# ADDENDUM NO. 1

Project Name: Oslo Riverfront Conservation Area Wetland Overlook

Reconstruction

RFP Number: RFP 2019037

Please refer to the "Southeast Lookout Tower #98"

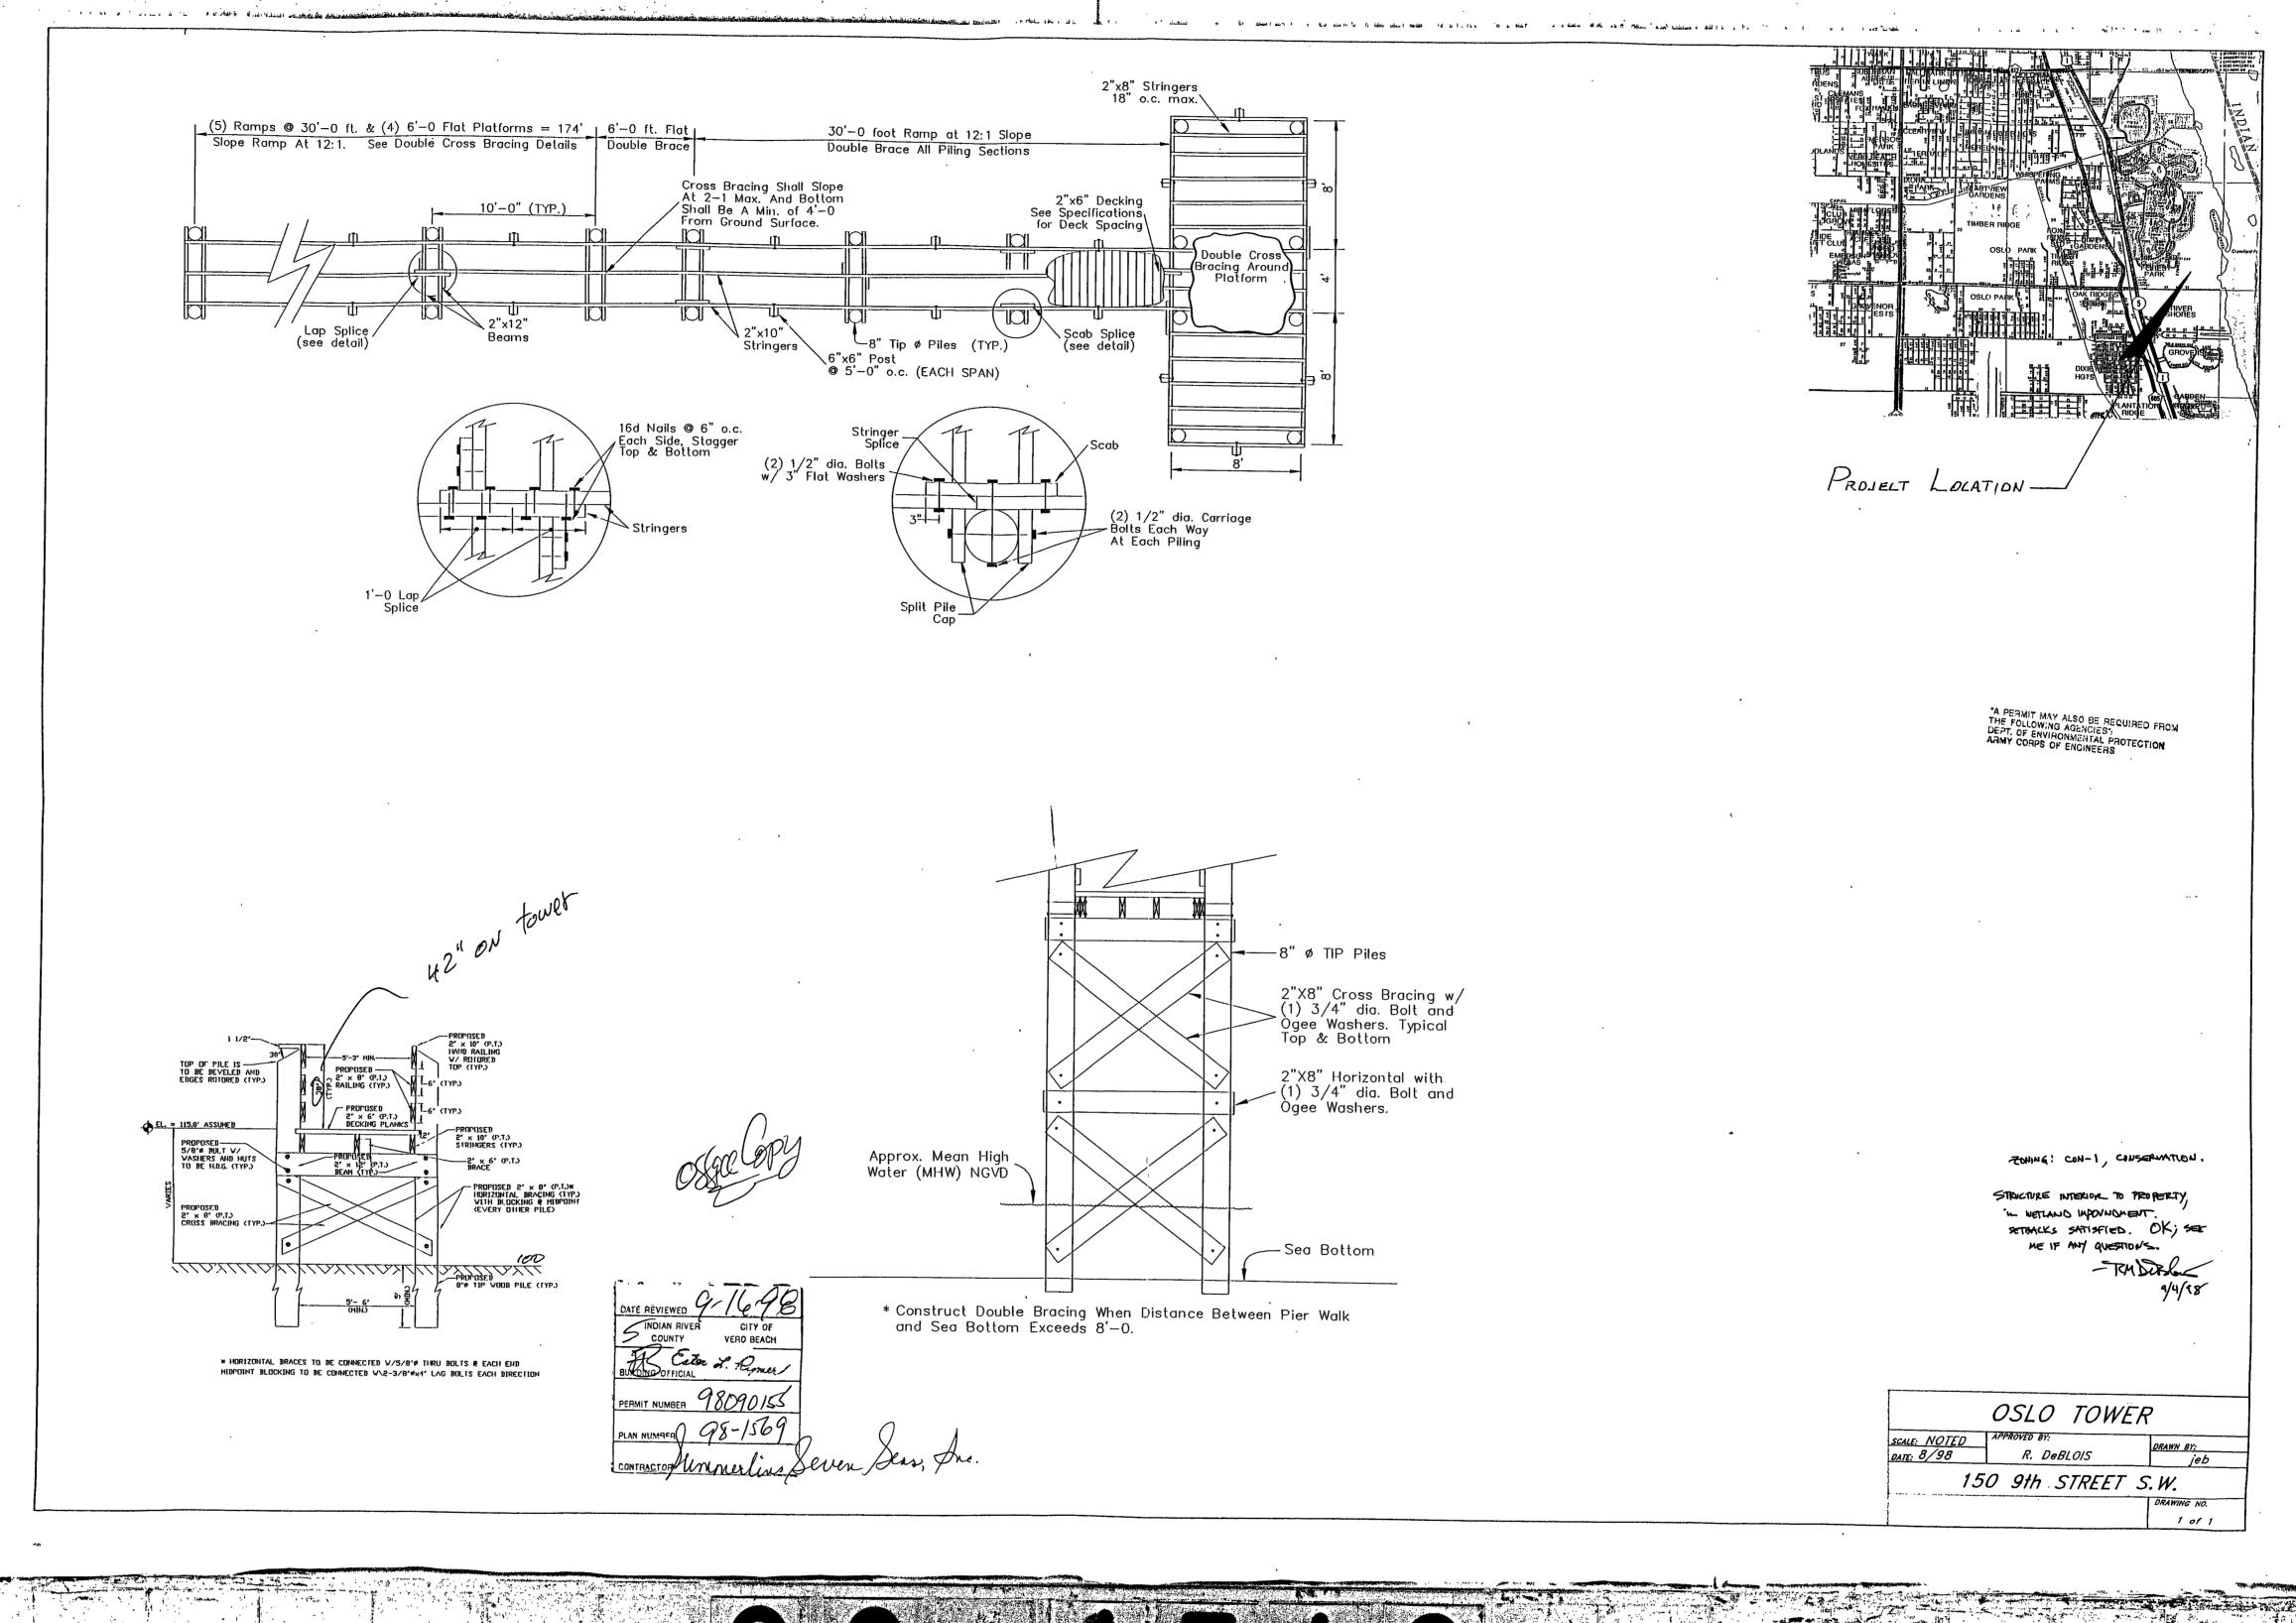
11. Please provide the plans for the original construction.
